APPENDIX 3

PHOTOGRPHS OF MODIFICATION

Modify Description

View of Panel

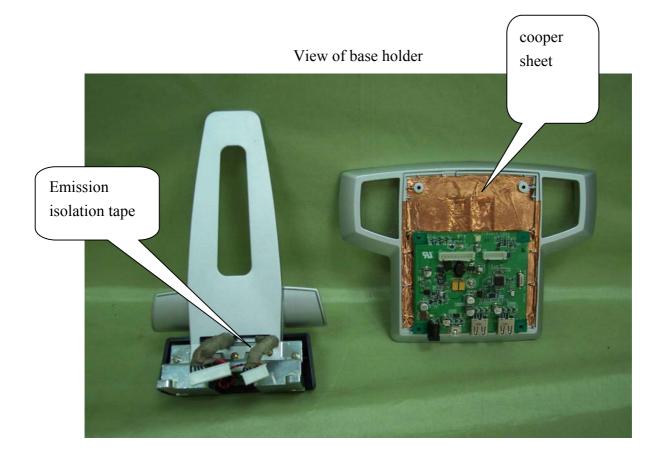
- 1. One cooper sheet provides at base holder, see photo for details.
- 2. Emission isolation tape provides at signal cables, see photos for details.
